PERFORMANCE BULLETIN 136

V424 & VAV4 Series Shaft Guide Update

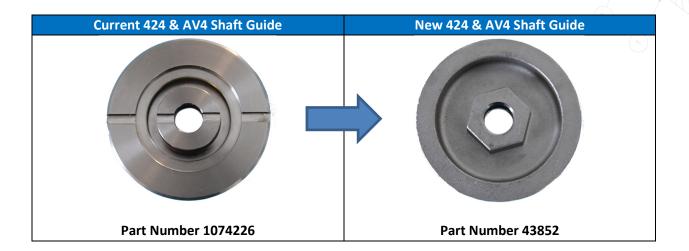
Shaft Guides for 1.25" and 1.5" metal valves (V424 and VAV4) are being updated to use a new investment cast design. The fit, and function of the parts will remain unaffected and the new Shaft Guides will be fully interchangeable with the old.

The new style Shaft Guides will feature a 3/4" hex for easy removal and installation. This eliminates the need for special tool PN 1074227 to remove the Shaft Guide. The Shaft Guides will remain 303 Stainless Steel material. As a result of this update, the Part Numbers will be changed as shown below. Kits containing the Shaft Guides will not change Part Numbers. The update will be implemented when inventory of the current machined version is exhausted.
